Informational Base Scenario Update (Order No.1920 Scenario Development Track)

TEAC Special Session - Order 1920

October 10, 2025

Review feedback on Informational Base Scenario Input assumptions

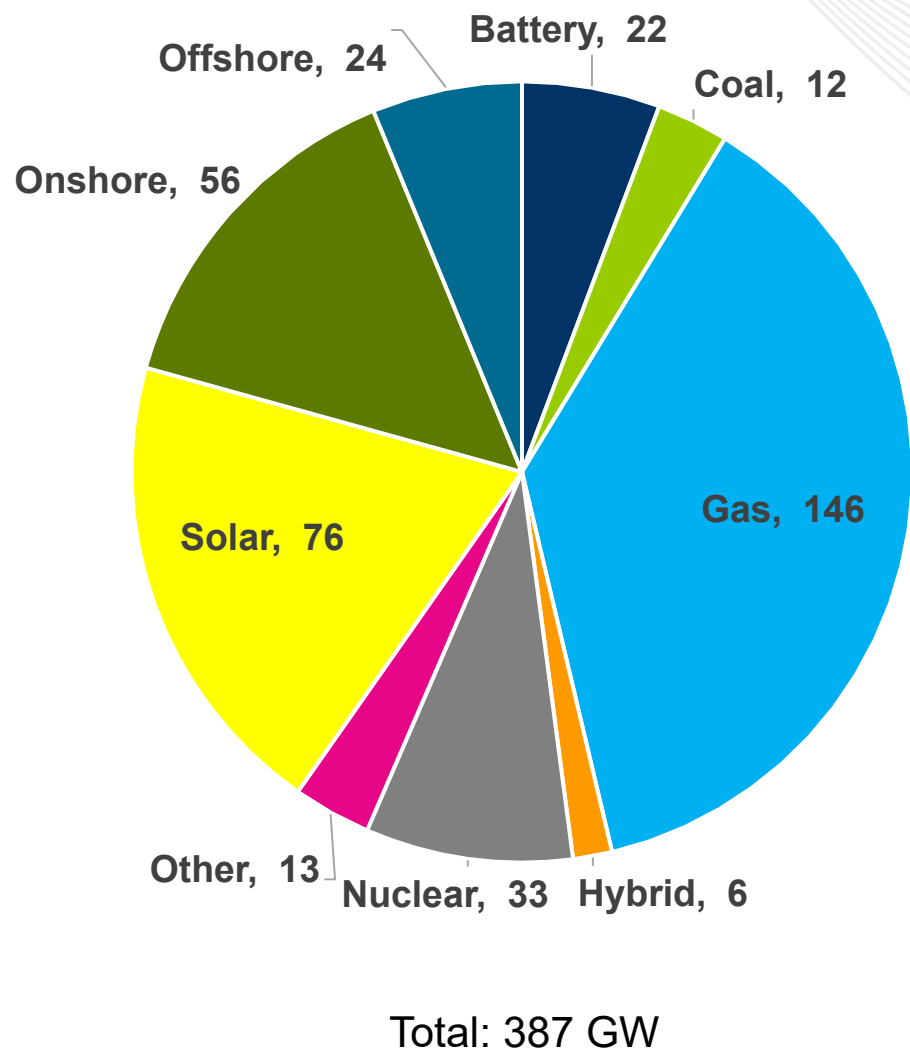
- Comment: Why all solar units being added between 2035 and 2045 are projected to come online in one region (Dominion).
- PJM's response: The model favors building in areas with better solar prospects including lower costs and higher capacity factor.
